Source: Prestolite Electric Leece Neville Heavy Duty Systems
Bulletin No: TWB-0101 **Date:** October 31, 2023
Models: 24V BL4000 series
Subject: Wiring Diagram

24V BL4000 Series wiring diagram.

Bulletin No: TSB-0101

Fig 1

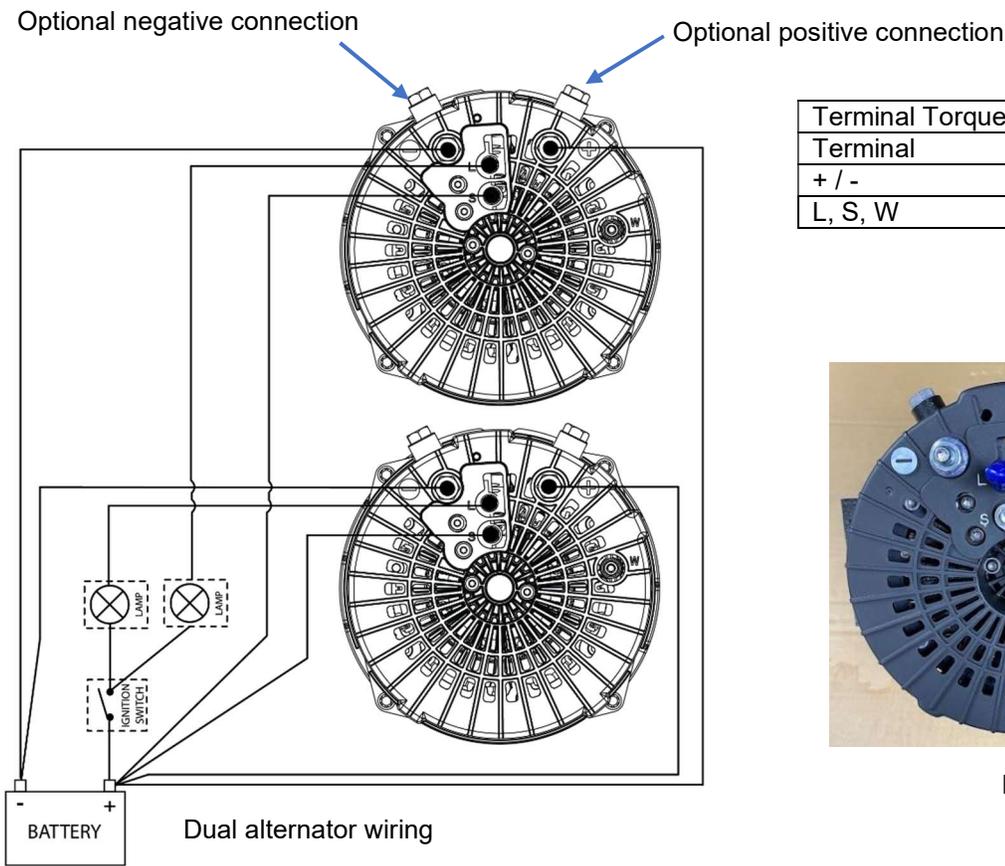
Sense (S): Operation voltage 28.4 with or without sense terminal connected. Connection to sense terminals is required for alternators to load share. If the remote sense terminals are not used in the application a (A049104702S) jumper wire is required between the alternator's (+) and (S) terminals. See (Fig 1) This wire will need to be purchased separately.
